SUBMITTAL OF HANFORD FACILITY RESOURCE CONSERVATION AND RECOVERY ACT (RCRA) PERMIT MODIFICATION NOTIFICATION FORM 24590-HLW-PCN-ENV-06-015

Hanford Facility RCRA Permit Modification Notification
Form 24590-HLW-PCN-ENV-06-015

24590-HLW-PCN-ENV-06-015

The purpose of this Class 1 prime modification is to update the Piping and Instrumentation Diagrams (P&IDs) for the HLW Radioactive Liquid Waste Disposal System (RLD) in Appendix 10.2 of the Dangerous Waste Permit. The following source P&IDs are submitted to replace the permit P&IDs currently in Appendix 10.2.

24590-HLW-M6-RLD-20004

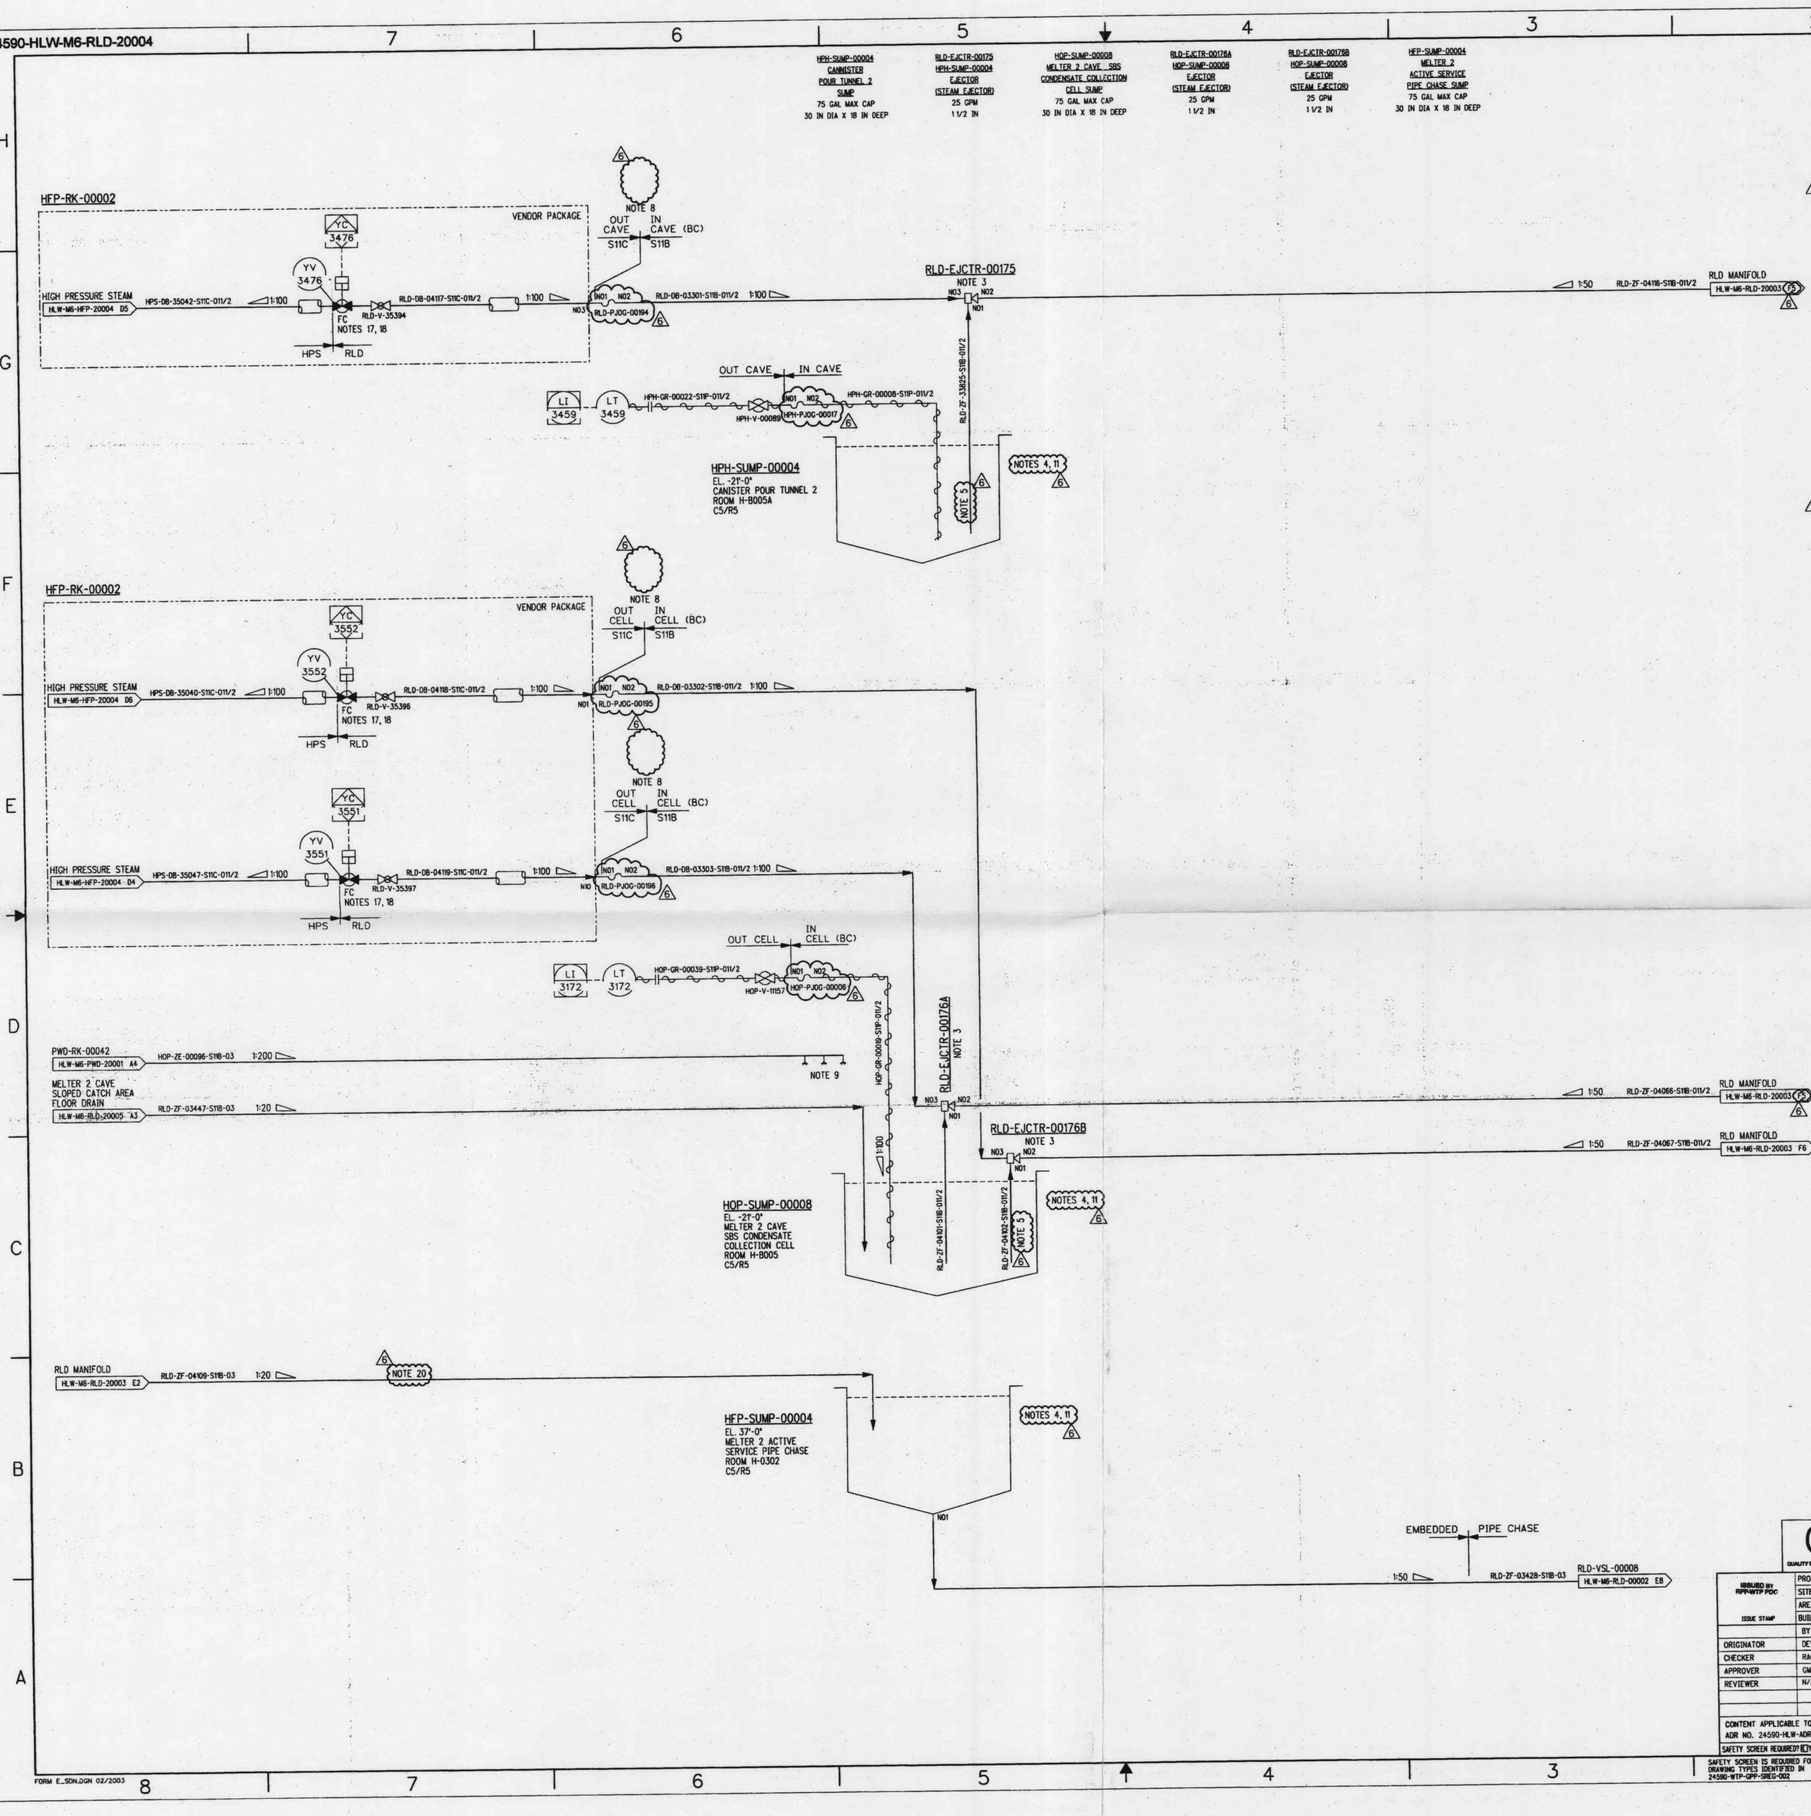
- Relocated tank HSH-TK-00002 to P&ID 24590-HLW-M6-HSH-20004
- Rearranged incoming lines to Manifold
- Added removable basket inside sump HSH-SUMP-00009

22. REVISED TO INCORPORATE P-JOGGLES AND 24590-HLW-M6N-MB0T-00007. ADDED/REVISED/DELETED NOTES, HOLDS, AND REFERENCES. REVISED QUALITY/SEISMIC BREAKS.
